SERVICE BULLETIN

Title: Calibration of Furnas Solid State Overloads

Models Affected: Centrifugal Water Chillers

Number: C9203

FIGURE 1

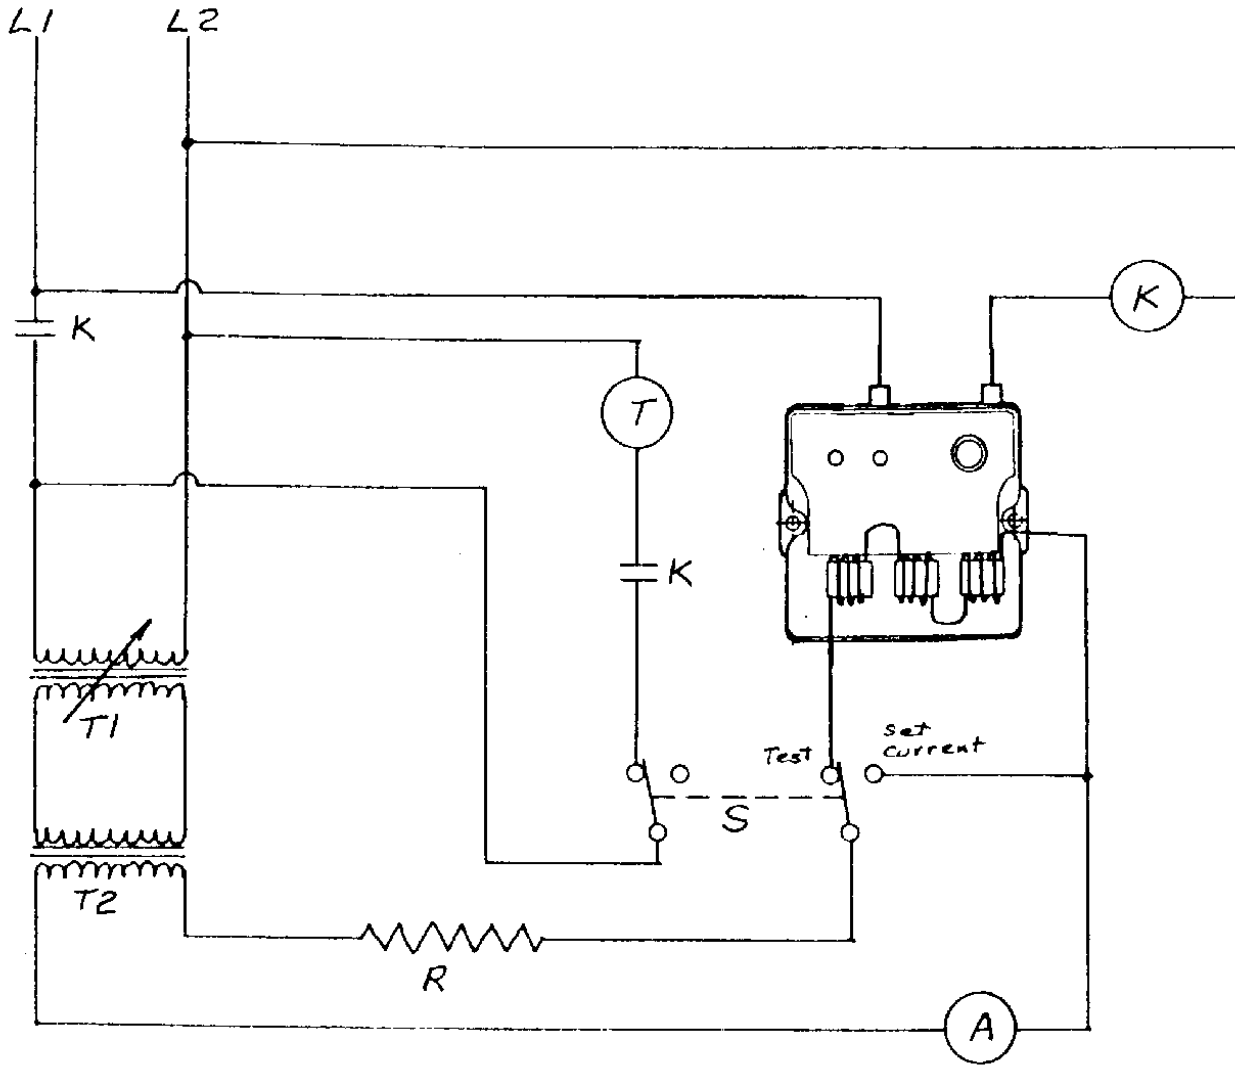
It is acceptable to calibrate the overload using a single phase AC current source provided that the wire is routed through the overload relay loops as shown on **Figure 1**. If the relay is calibrated with incorrect routing of the wire and then installed with proper routing of the wire, the relay will trip when the current is 5% too low.
